UNITED STATES PATENT AND TRADEMARK OFFICE

APPLICATION NO.	FILING DATE	FIRST NAMED INVENTOR	ATTORNEY DOCKET NO.	CONFIRMATION NO.
10/646,639	08/22/2003	Thomas J. Fogarty	ARB-9003	9788

Office Action Summary

Fig. 1

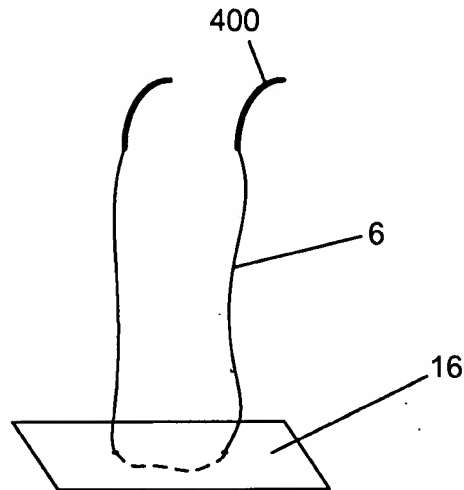
Figure 1 to 3 should be designated by a legend such as --Prior Art-- because only that which is old is illustrated. See MPEP § 608.02(g). Corrected drawings in compliance with 37 CFR 1.121(d) are required in reply to the Office action to avoid abandonment of the application. The replacement sheet(s) should be labeled
